PLAN FOR PROPOSED BUILDING ON PLOT NO. 64, RB. II.

KARACHI MUNICIPALITY.

REFERENCE No. B. S. P. 283 OF 1932

Re Building ~~XXXX~~ on plot No. 64, R.B. 11, Rambaugh.

PLAN FOR PROPOSED BUILDING ON PLOT NO. 64, RB. II.

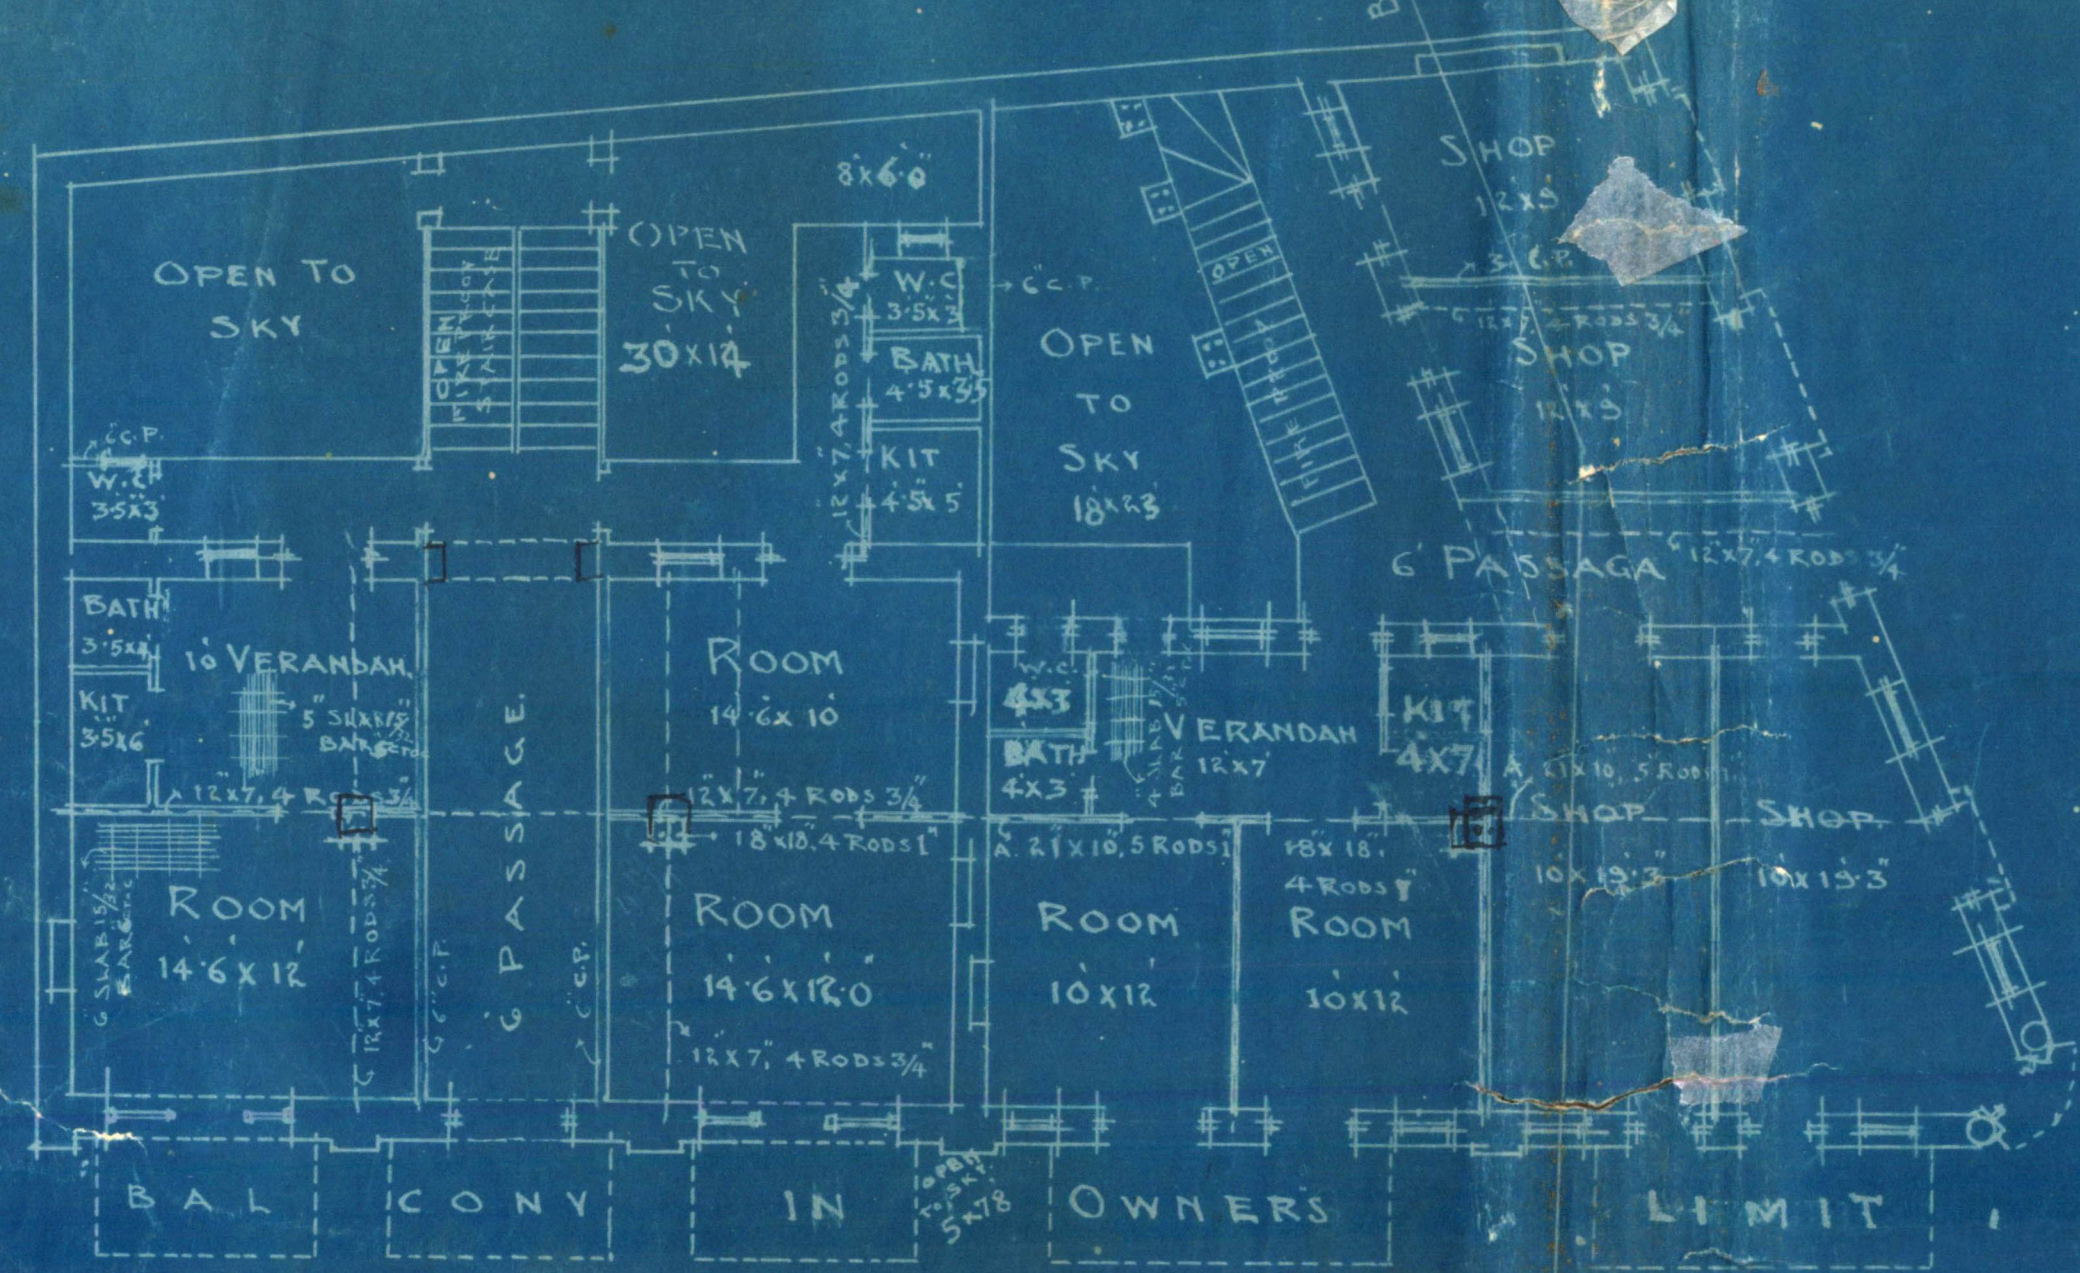
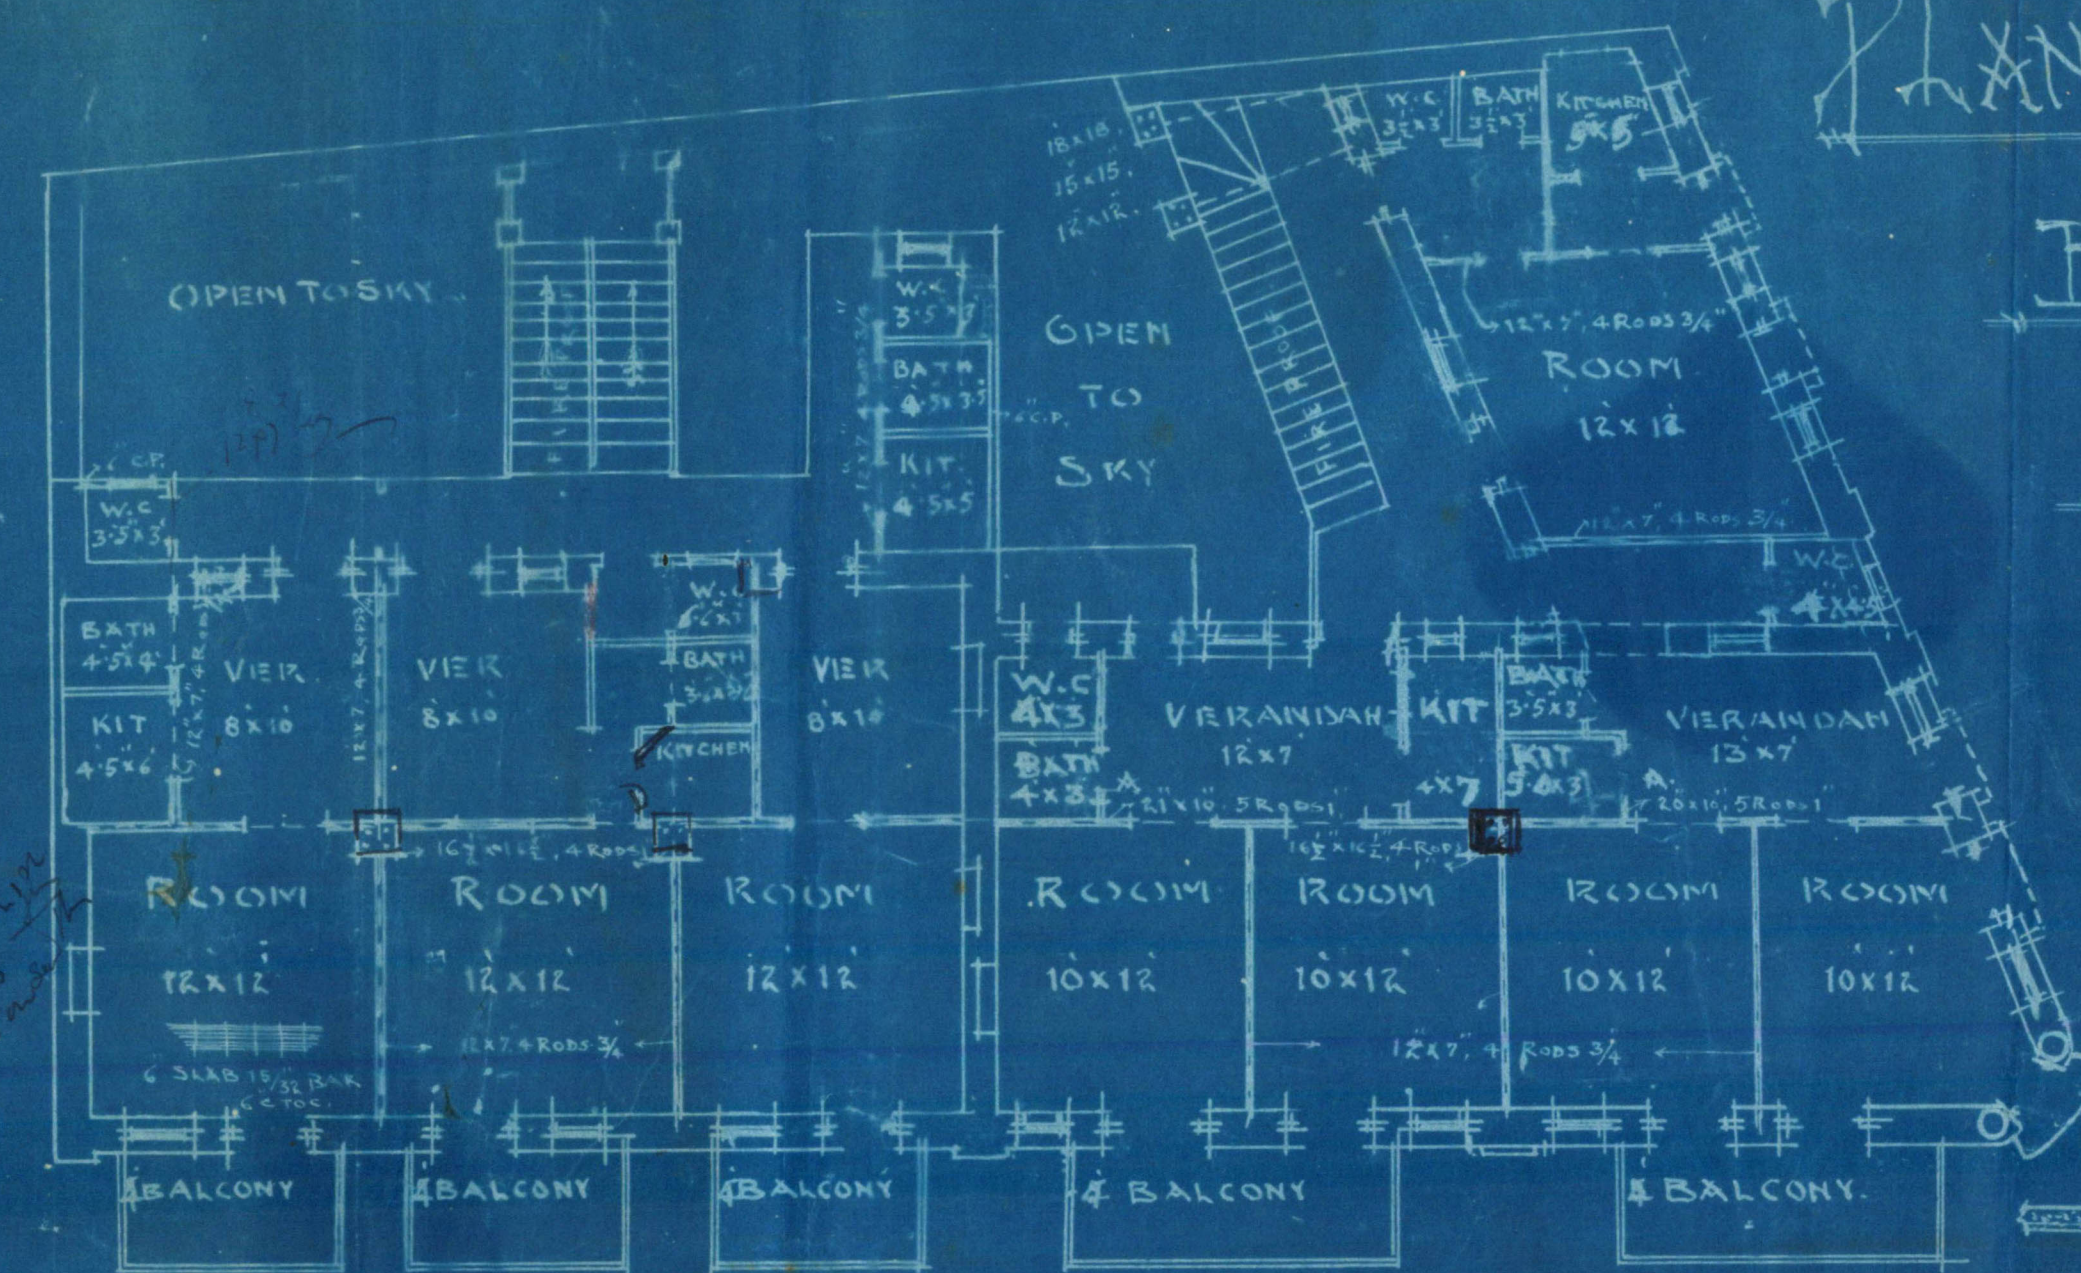
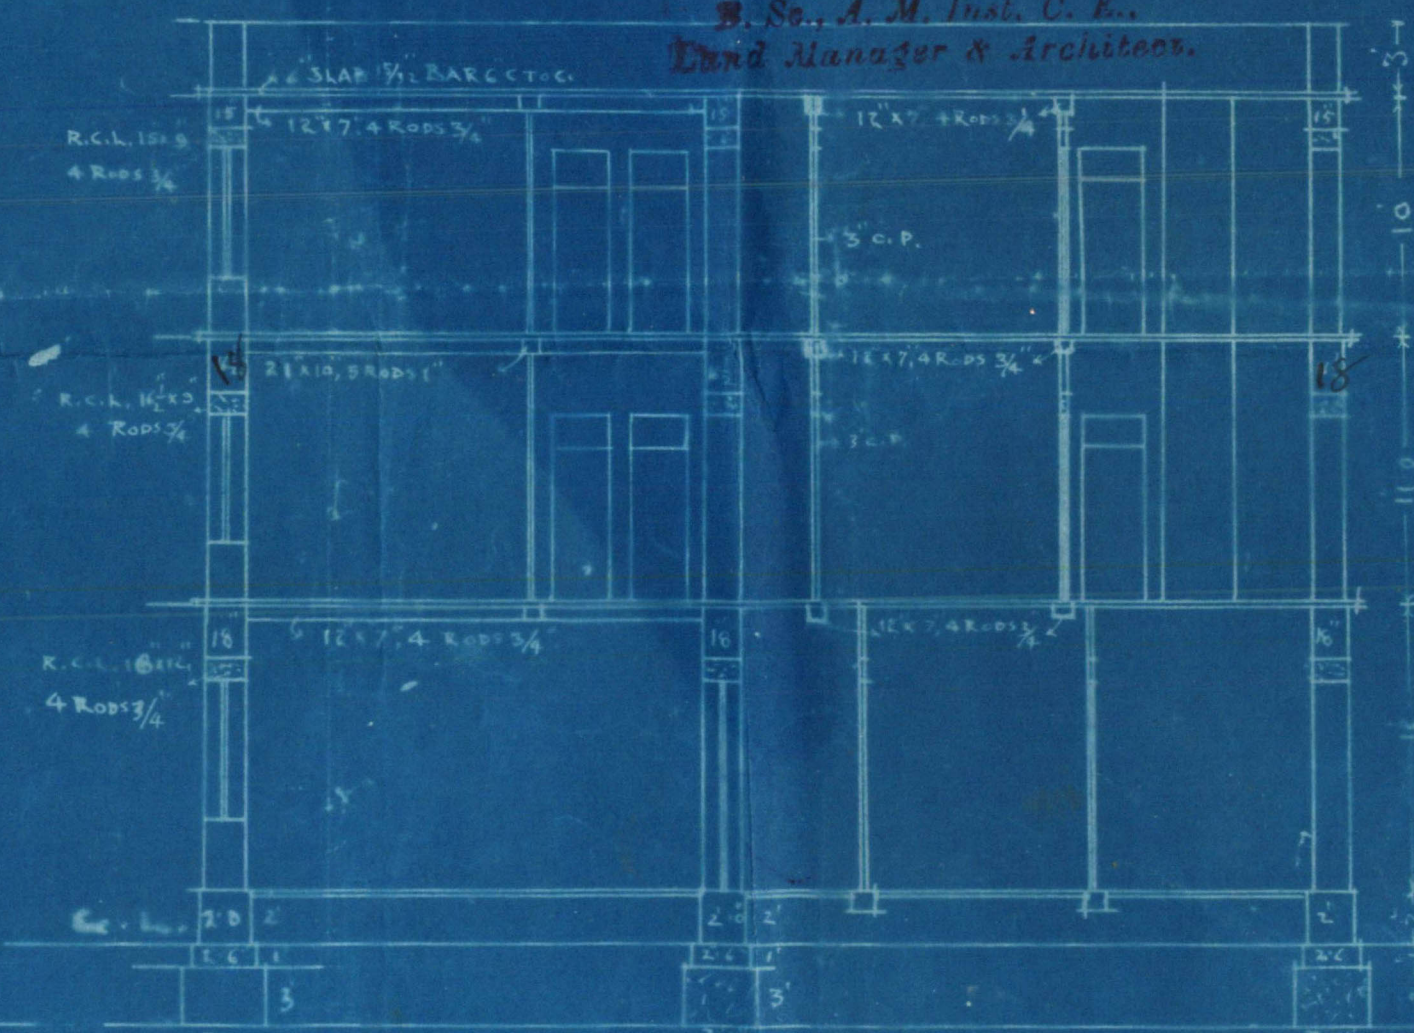
There are several corrections made on the mounted fly. The architect is made to make necessary changes in his tracing

c
1. ask the architect to send more copies duly corrected as per copy on clock.

Plans may be approved then is no objection -
